SUBJECT: Provides response to request for addl info re proposed TS
Amend 136a for pressure boundary redefinition for
Westinghouse hybrid expansion joint sleeved tubes.

Docket 50-305
Operating License DPR-43
Kewaunee Nuclear Power Plant
Proposed Amendment 136a to the Kewaunee Nuclear Power Plant Technical Specifications,
Pressure Boundary Redefinition for Westinghouse Hybrid Expansion Joint Sleeved Tubes

**Response to Request for Additional Information Related
to Proposed Technical Specification Amendment 136a:
Pressure Boundary Redefinition for Westinghouse HEJ Sleeves**

Figure 4

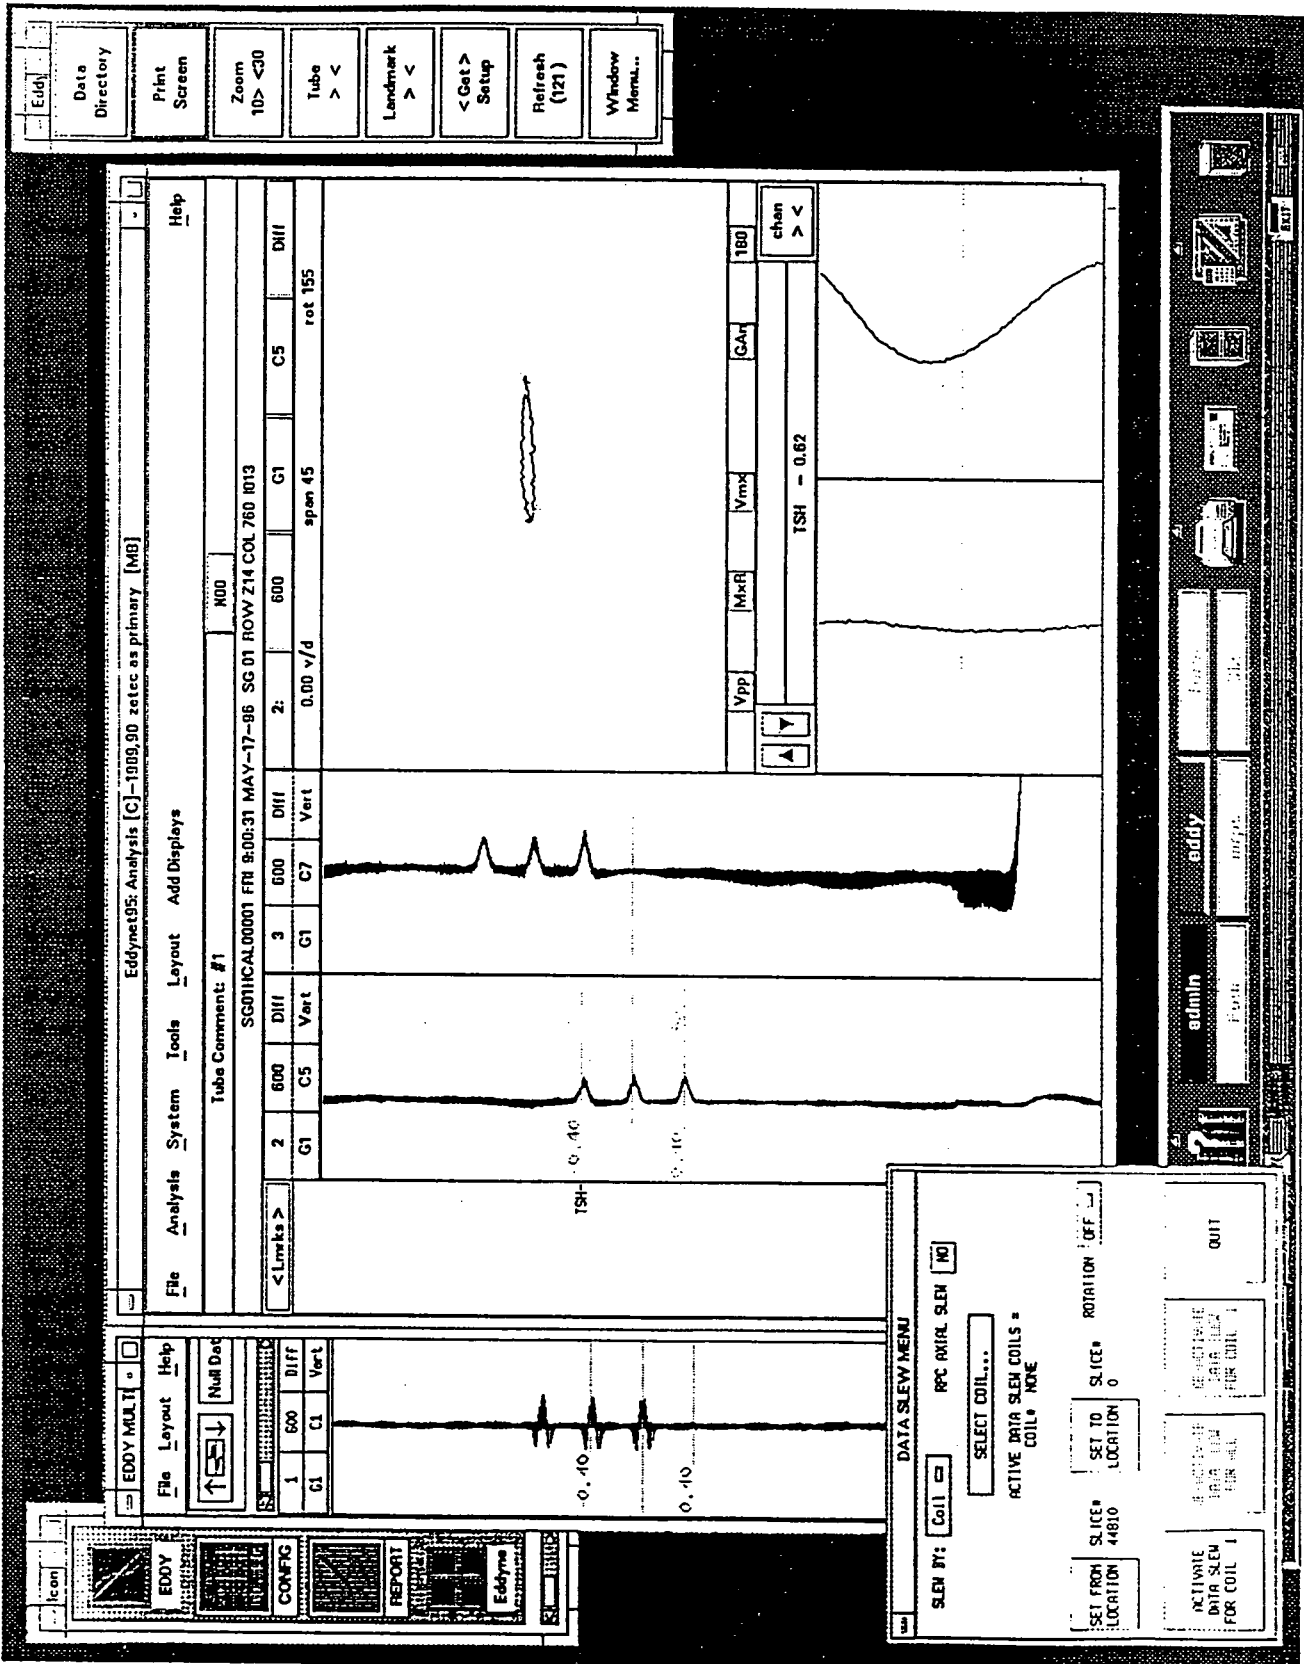
Identify and explain all potential variables (e.g., variations in probe speed, coil spacing (consistent with dimensional tolerances), probe wear, calibration standard variances (within dimensional tolerances, human factors, etc.) affecting the accuracy of the slew (i.e., the degree to which the bobbin diameter data correspond to the exact location of the plus-point data). This definition of "accuracy of the slew" is different from the one given in previous discussions which simply referred to how well the slewed profiles from each bobbin coil line up with one another, or how much they are "offset."

Explain how each of the variables affecting the accuracy of the slew is to be controlled. This should include an explanation of the use of an axial encoder for ensuring consistent translation speeds and should address the range of speeds which will be permitted? Regarding coil spacing, how well (quantitatively) can this be controlled with the use of the calibration standard, considering its dimensional tolerances and also considering the different "look ahead" characteristics of bobbin coils versus plus-point coils. Will the use of the calibration standard to control coil spacing be demonstrated by performance demonstration? Provide comparative, quantitative information on the look-ahead characteristics of bobbin and plus-point coils. Explain what will be done if a combination probe fails to meet calibration test criteria.

Figure 4 shows the strip chart displays for each of the bobbin and +Point coils. Knowing that the data was recorded while pushing the probe through the standard containing three drill holes, we can see from the cursor position (designated as TSH) that bobbin coil 5 (C5) is passing over the third drill hole while bobbin coil 7 (C7) is just passing over the first drill hole. Also note that the +Point coil (C1) is at the second drill hole. In order to slew the +Point data we first define a start point. In this example the point at which the +Point coil is over the first drill hole is chosen (Figure 5). The Data Slew Menu box shows the cursor position to be at data slice #44810. Next a point to slew the data to is chosen. The cursor position in Figure 6 is where bobbin C5 passes directly over the first drill hole, at slice #39727. Activating the data slew for +Point coil #1 repositions the data so that it appears to occur in time with C5. The data slewing process is repeated for bobbin coil 7. The Data Slew Menu box in Figure 7 shows the From/To data slice values of #49567 and #39780, respectively. With the data slews activated for coils 1 and 7, we can see from the strip charts in the figure that responses from each drill hole appear to occur simultaneously.
